REGIONAL REVIEW FINDING

ARC REVIEW CODE: R1912101

Name of Proposal: Huber Street Ready-Mix Concrete Plant (DRI 2934)

SHEET TITLE:
SITE CONCEPT PLAN

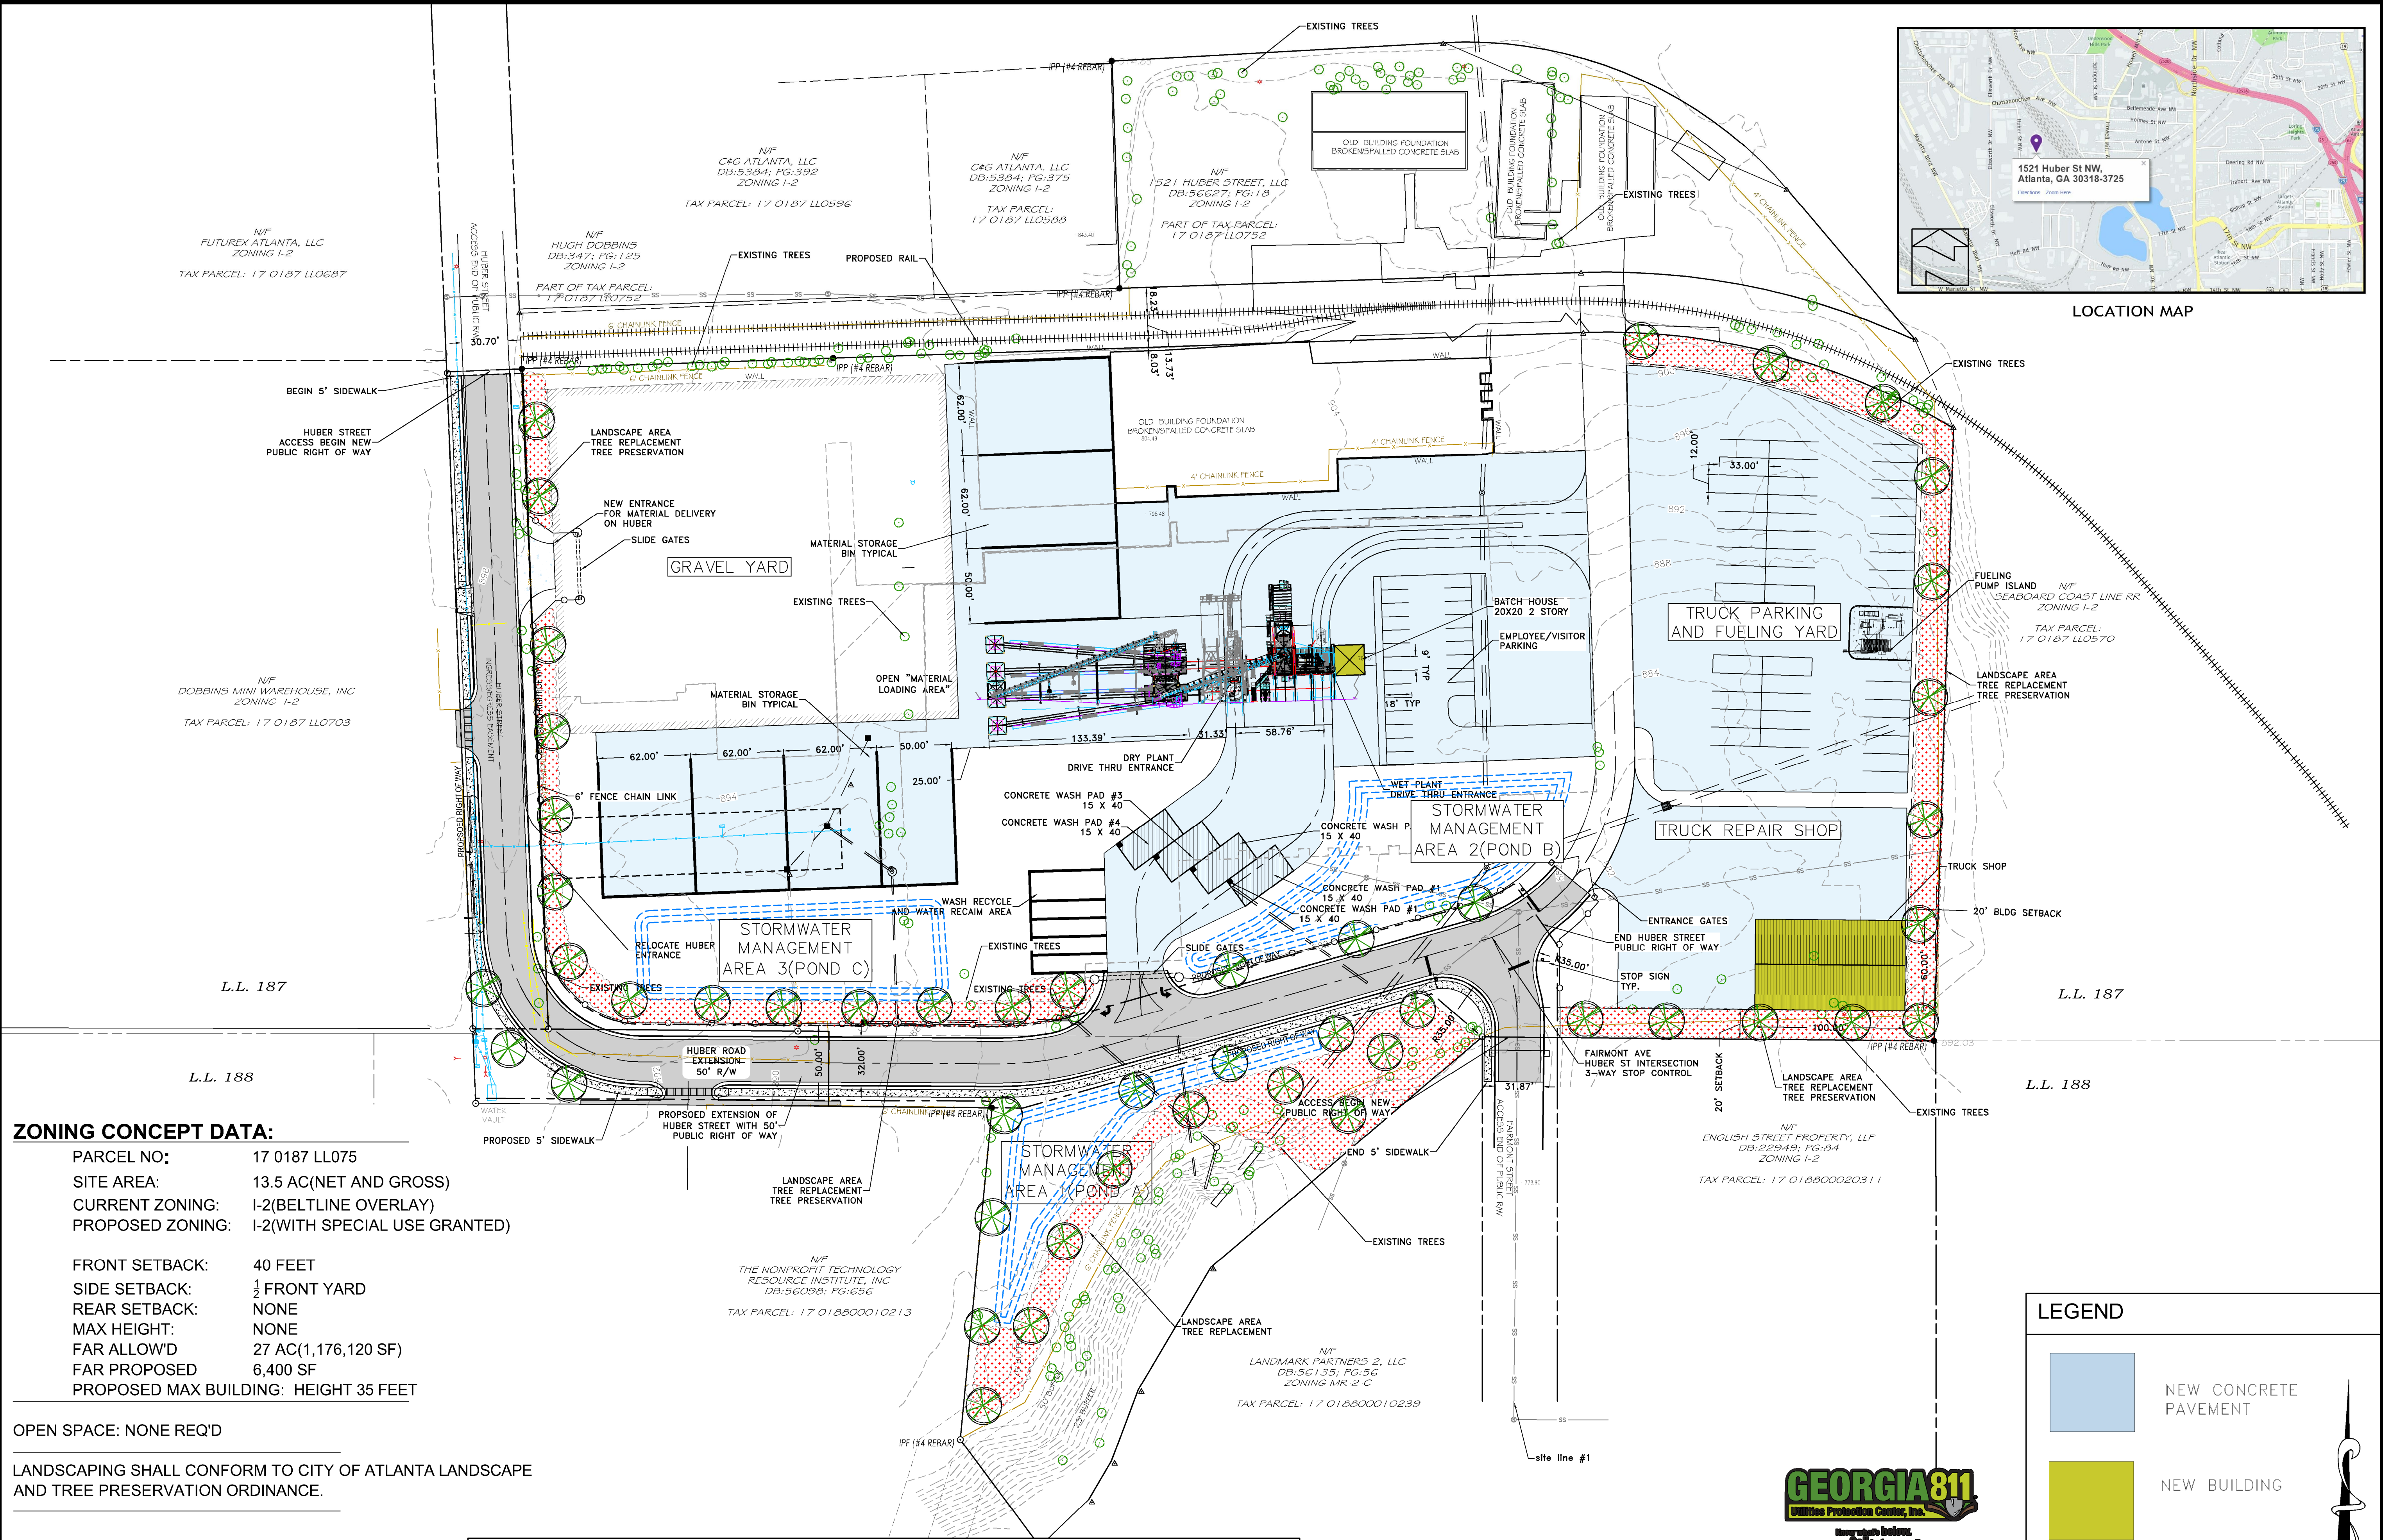
The site plans have identified a proposed detention pond located downgradient of former paint production facility. There is a concern that future mounding of water in this area may mobilize historic soil and groundwater impacts, originating from the property, towards the off-site tributary of Woodall Creek and the residential neighborhood. There was no soil and groundwater quality data in this area to confirm that this would not occur.
